**Subject: *Roseboro Emergency Services Building - Sampson County
Addendum No. 3
Bid Question Response to RFB Issued 06/ 19/ 2026***

On behalf of our client, Sampson County (County), Kimley-Horn and Associates, Inc. is providing Addendum No. 3, dated 06/ 19/ 2026 in reference to the above-mentioned project. The following has been is attached for reference.

A-101
SHEET 1 OF 5

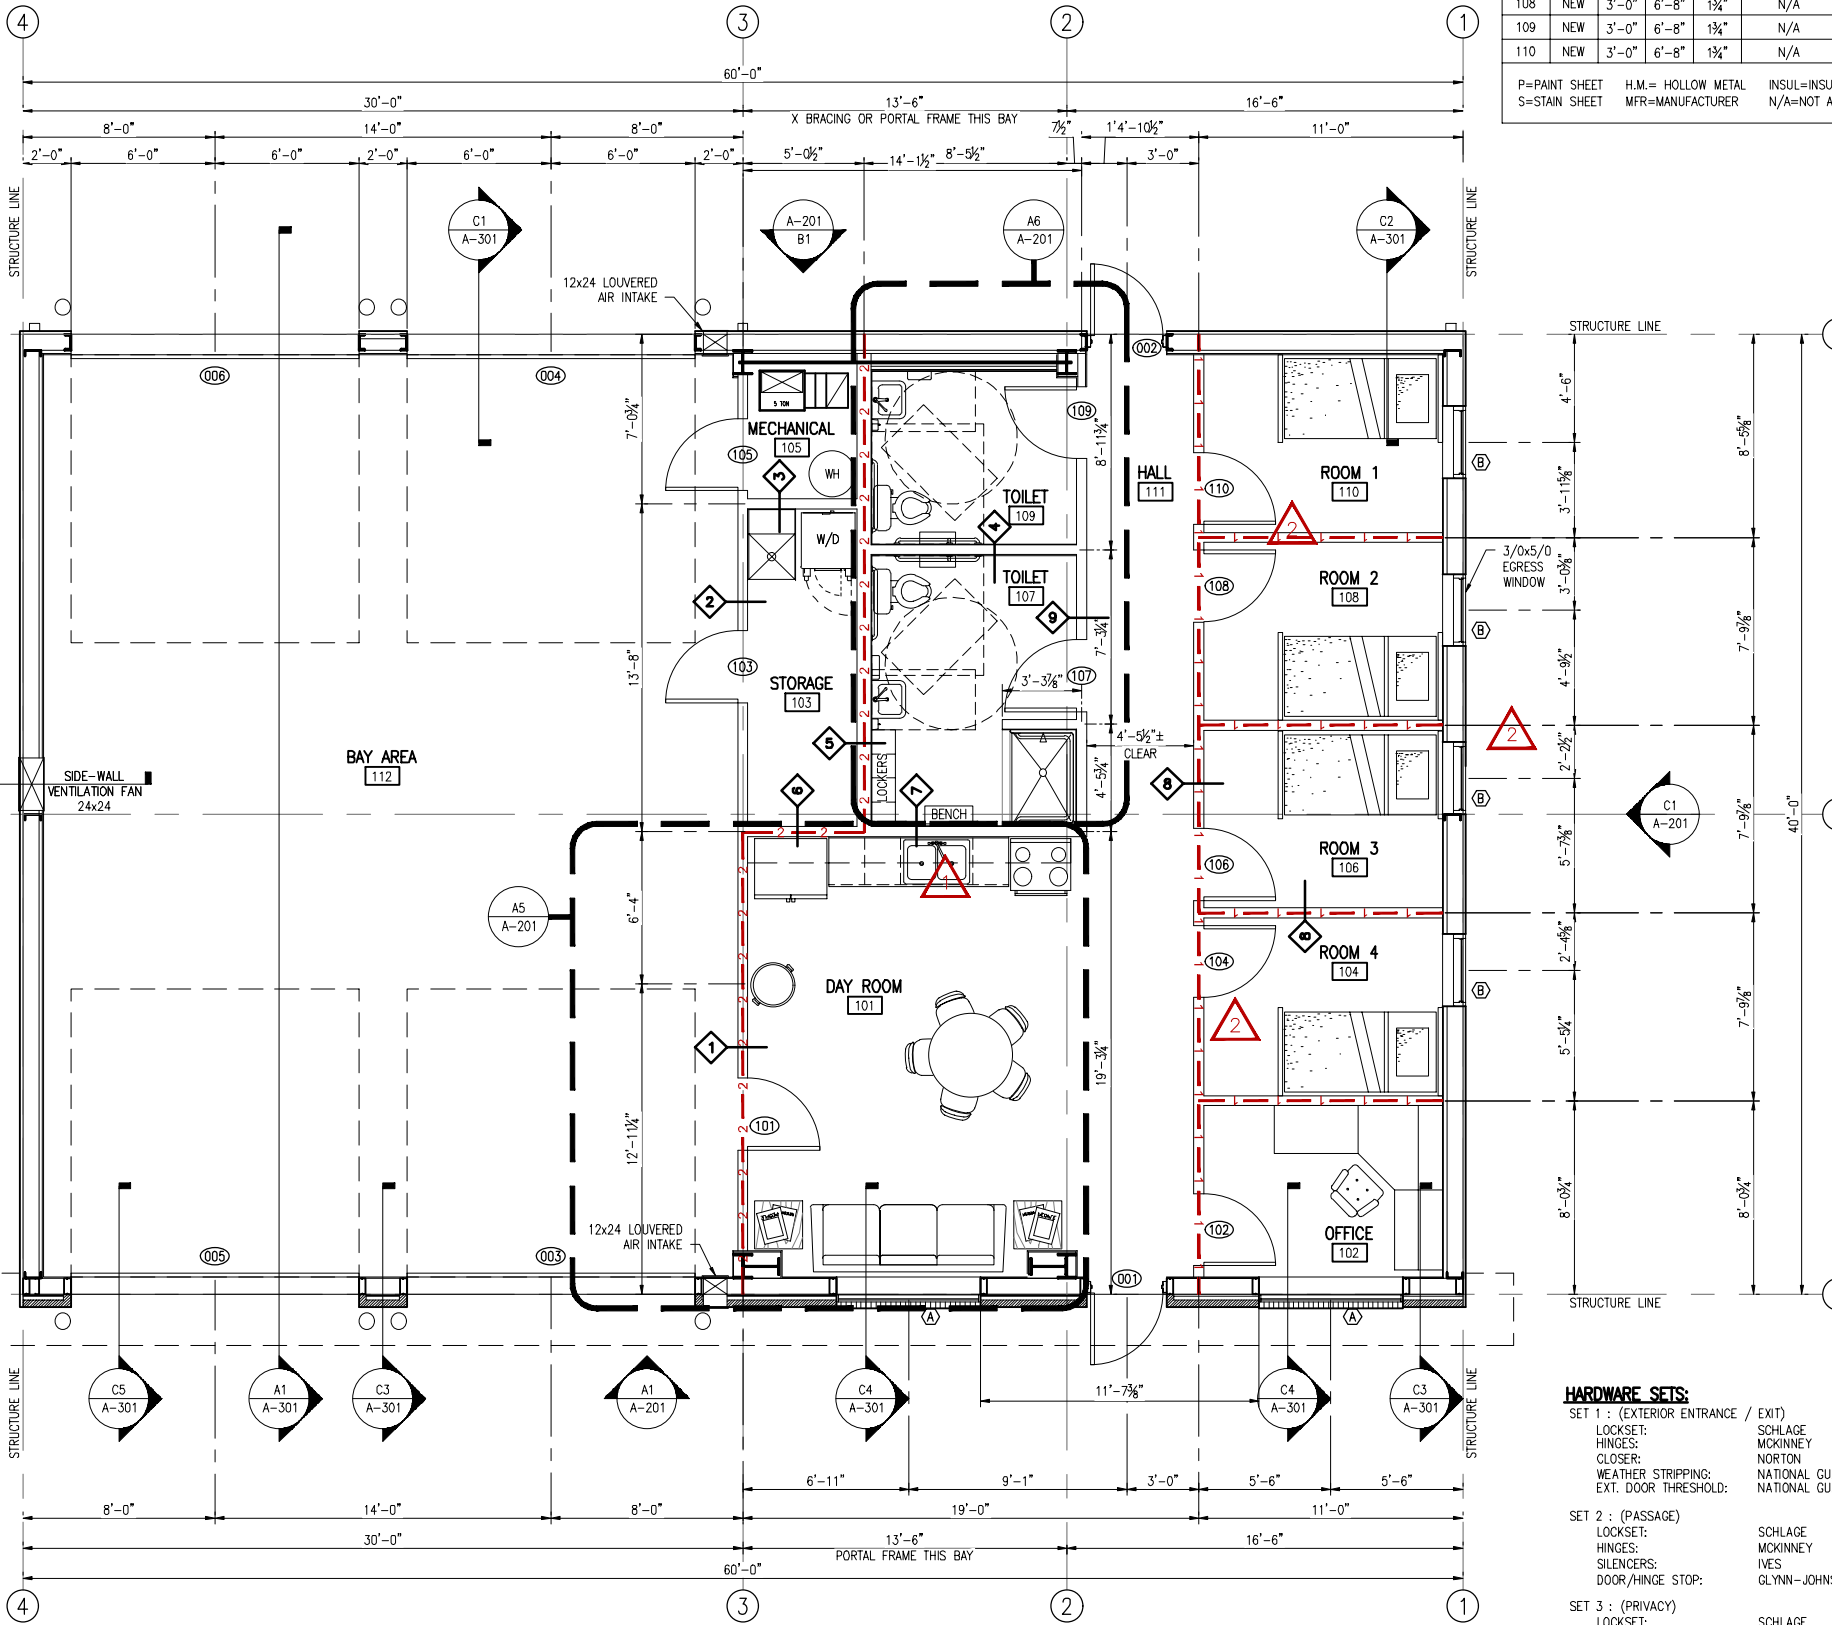
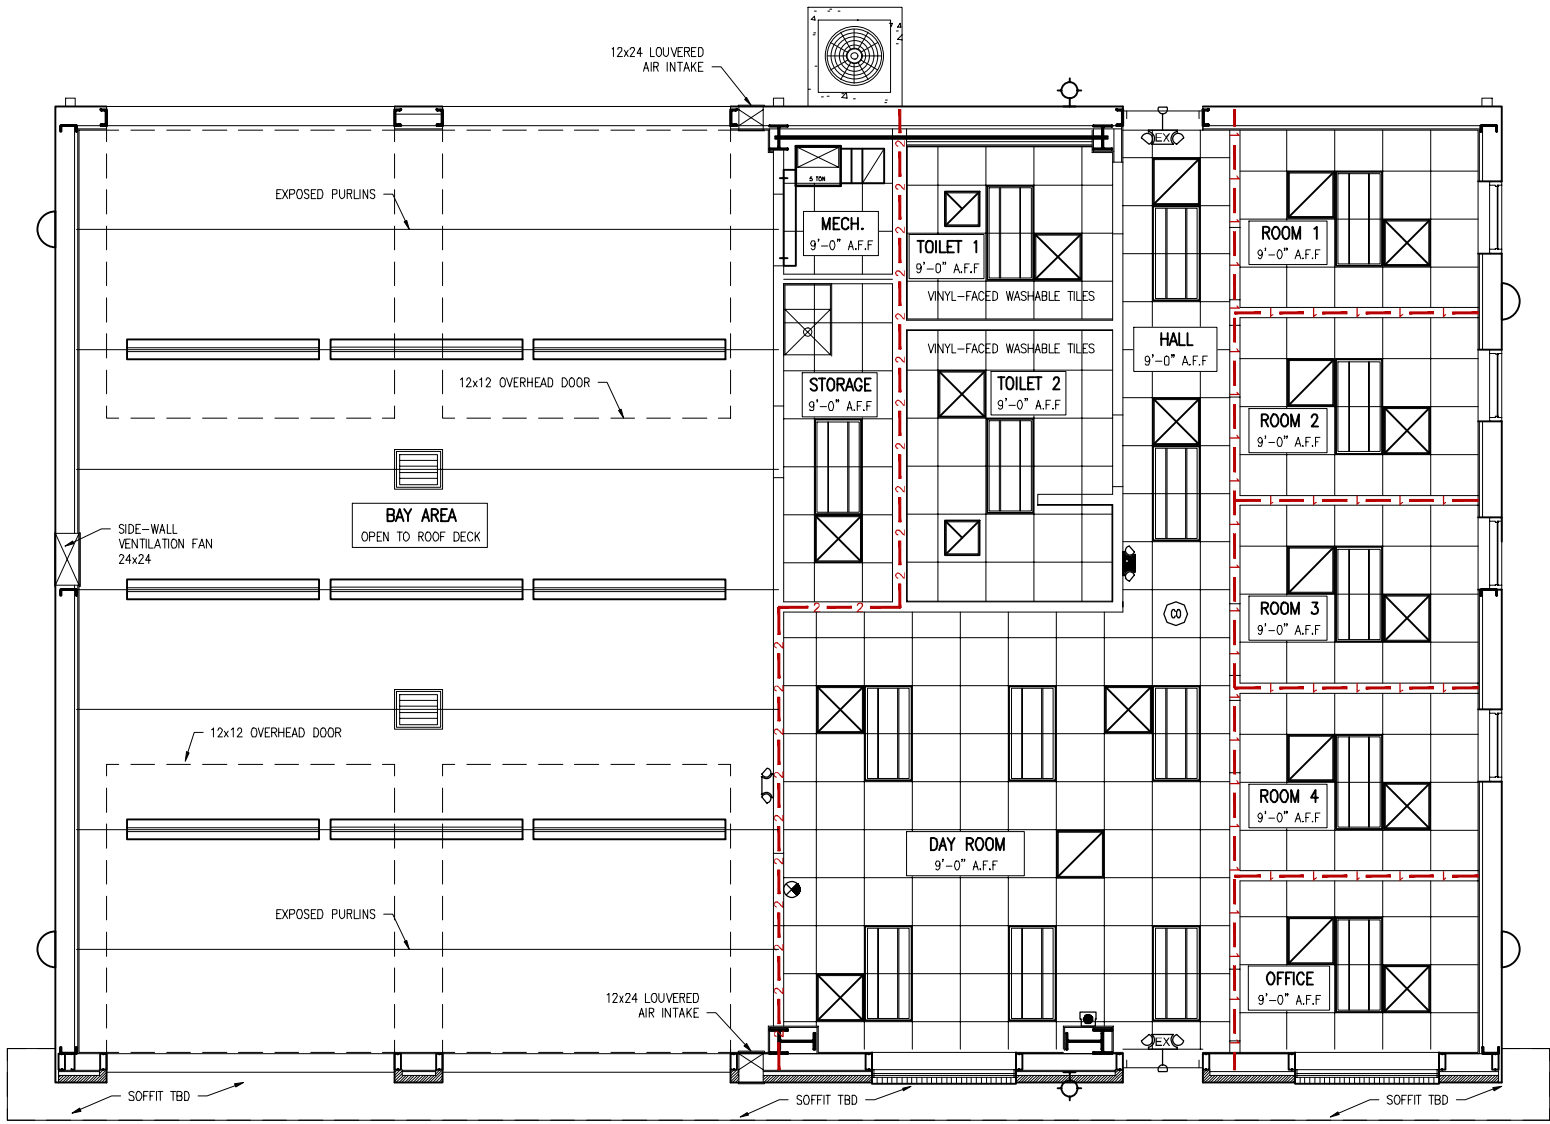
18. A-101 References C3/ A-301 Wall Detail for the Bay Area. Is the intent to have drywall and lay in ceilings in the bay?

Response 18: Reference tag C3/ A-103 in the truck bay should say "similar to". No ceiling in the truck bay but the wallboard does extend to the top track per the section. Also refer to Sheet A-102 for ceiling questions.
